Customer Satisfaction Campaign – Replacement of bleeder valve – W 203 (C 200 CDI)

**Service Measure - Check connectors and low pressure hoses of the high pressure pump unit, replace, if necessary.
 Model 211 with engine OM 646, 647, 648**

**Supplement to Service Measure dated 12th October 2004 (Accounting No. 07 930 06)
Check injectors and ZME; replace, if necessary.**

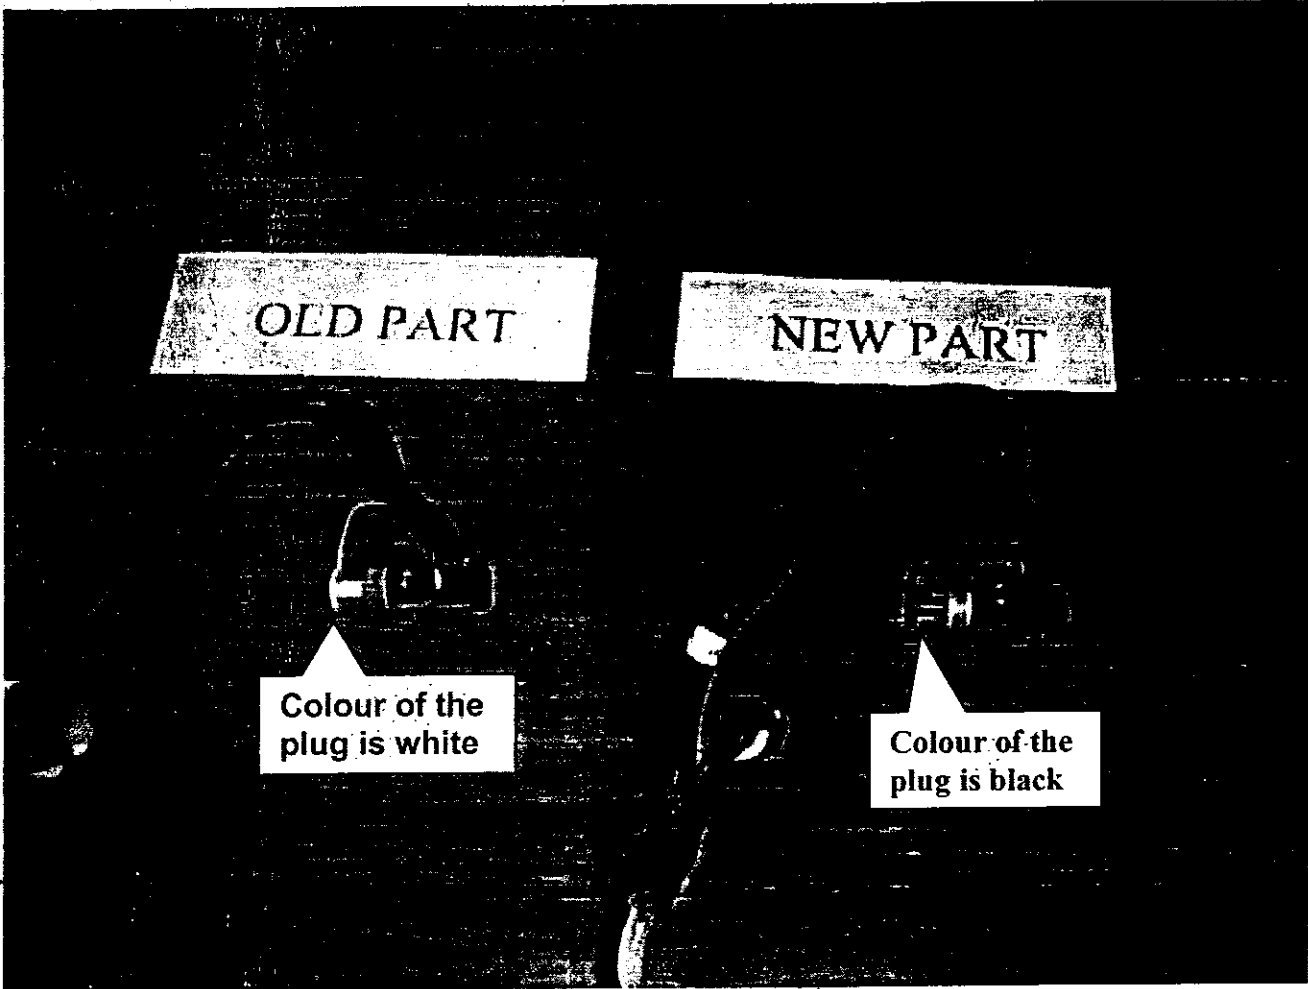
We are enclosing herewith a photograph of the new & old bleeder valve for your ready reference. Please ensure that the bleeder valve is replaced only if you find an old bleeder valve on the vehicle. We are also enclosing herewith a list of the chassis numbers on which bleeder valves have already been replaced in the field.

OLD PART

NEW PART

**Colour of the
plug is white**

**Colour of the
plug is black**

Kindly instruct your parts department to keep adequate stock of the parts so that the vehicles can be attended immediately during their visit to the workshop. Kindly note that as per the new parts update, the bleeder valve is not separately available and is coming along with the line to which it is connected. Depending on the engine no. (not chassis no.), following two types of lines are to be used.

Part no. A 611 070 73 32 (from eng. No. 30 257722 upto eng. 30 368193)

Part no. A 665 070 01 32 (from eng. No. 30 368194)

**Check connectors and low pressure hoses of the high pressure pump unit, replace, if necessary
Model 211 with engine OM 646, 647, 648**

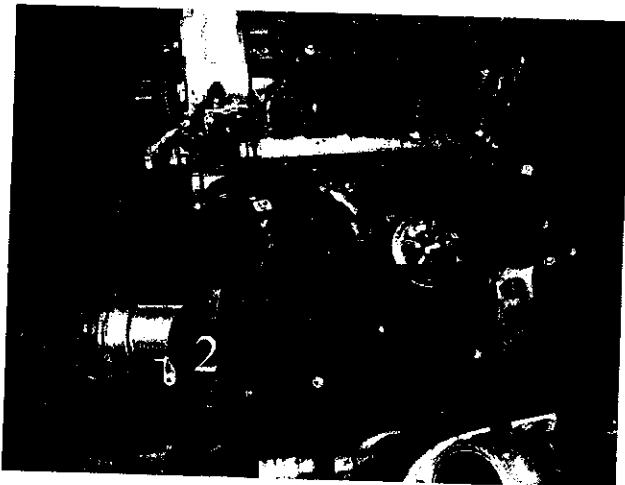
1. Remove design cover.
2. Remove cover plate (1) over connectors to low pressure hoses (2) at the high pressure pump unit
3. Spray contrast medium on connectors and low pressure hoses (2)
4. Check low pressure hoses for leaktightness, replace them if necessary.
5. Remount cover plate over connectors to low pressure hoses at the high pressure pump unit
6. Remount design cover
